# INNER WEST COUNCIL

## DEVELOPMENT ASSESSMENT REPORT

<b>Application No.</b>	10.2019.66.1
<b>Address</b>	29 Kingston Street, Haberfield
<b>Proposal</b>	Alterations and additions to an existing dwelling including rear extension and tree removal
<b>Date of Lodgement</b>	14 May 2019
<b>Applicant</b>	Andrew Burns
<b>Owner</b>	R Lim & L Fong
<b>Number of Submissions</b>	One
<b>Value of works</b>	\$1,078,000.00
<b>Reason for determination at Planning Panel</b>	Clause 4.6 variation exceeds officer delegation
<b>Main Issues</b>	Height, landscaped area and heritage
<b>Recommendation</b>	Approved with Conditions
<b>Attachment A</b>	Recommended conditions of consent
<b>Attachment B</b>	Plans of proposed development
<b>Attachment C</b>	Clause 4.6 Exception to Development Standard

01. GROUND FLOOR PLAN - PROPOSED 1:100

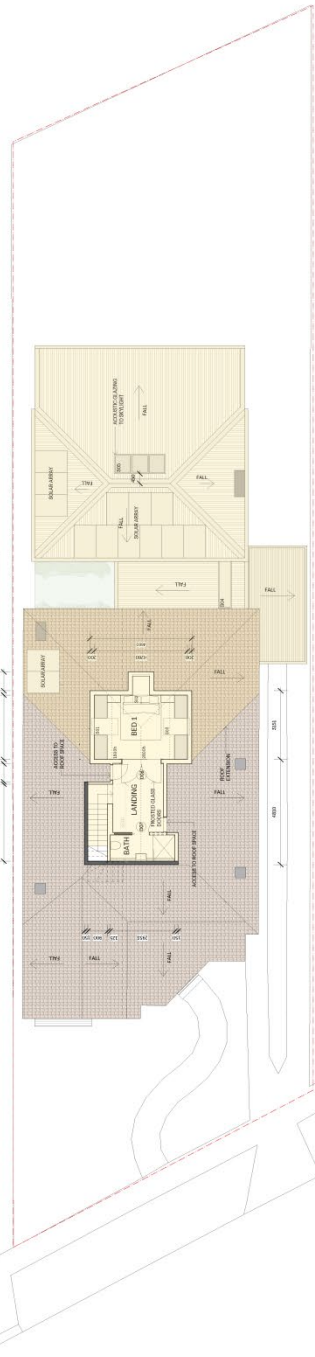
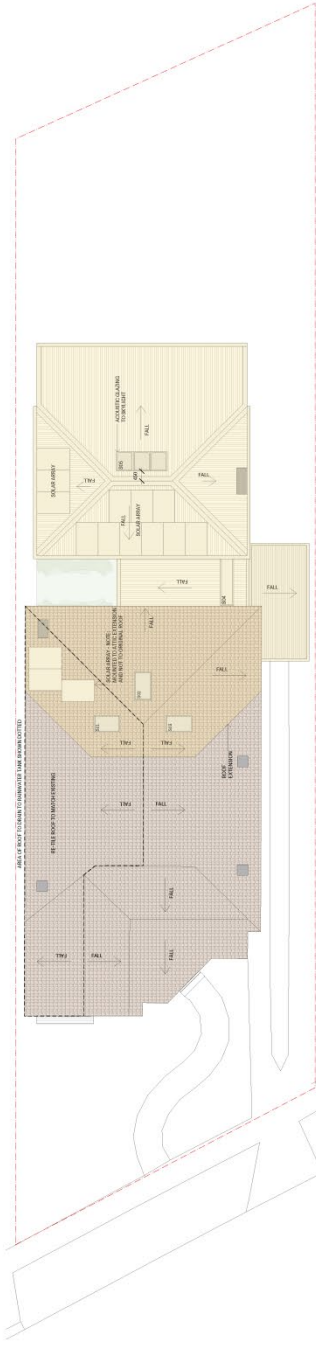
- The rear roof extension facilitating the attic space be amended to spring from a lower pitching plate, allowing the existing roof pitches to be maintained, therefore retaining the rear gablet of the distinctive gambrel roof form;

- The skylights on the rear attic addition be amended to be vertical in proportion;
- The skylights above the kitchen and lounge area be shifted downslope so that some roof appears above them, extending to the ridge;

- A Schedule of Materials and Finishes be submitted;
- The integration of the pavilion with the main house be amended to use the same tile cladding upon the pavilion (unglazed Marseilles pattern terracotta tile);

- The eaves of the pavilion roof be amended to be more consistent with the main house (exposed rafter-supported eaves);
- Windows W02 and W03 be amended to be of a scale and detail that is more responsive to the character of the existing house; and

- The proposal be amended to provide 50% landscaped area not including permeable pavers.

Amended plans were submitted to Council on 11 July 2019 which generally satisfied the above requirements. Following further consultation with Council's Heritage Advisor regarding

refinement of the roofing and window details, amended plans were submitted to Council on 13 August 2019 and 15 August 2019.

Above: Elevation diagram indicating non-compliant portion of proposal shaded blue – confined to the ridge only.

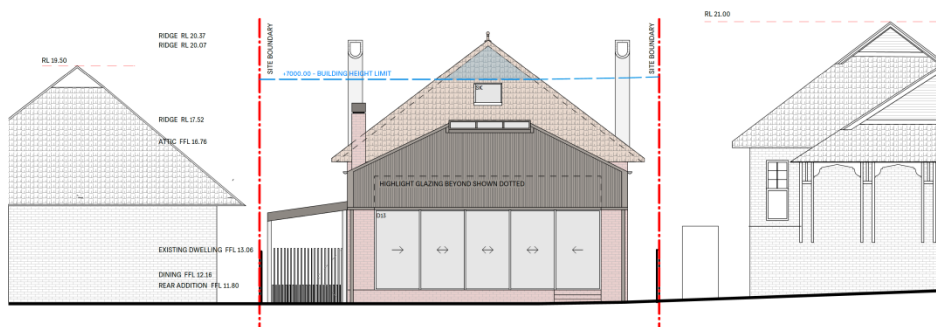
The applicant seeks a variation to the Height of Buildings development standard under Clause 4.3 of ALEP 2013 by 13.4% (940mm).

The applicant's written rationale adequately demonstrates compliance with the development standard is unnecessary in the circumstances of the case, and that there are sufficient environmental planning grounds to justify contravening the development standard.
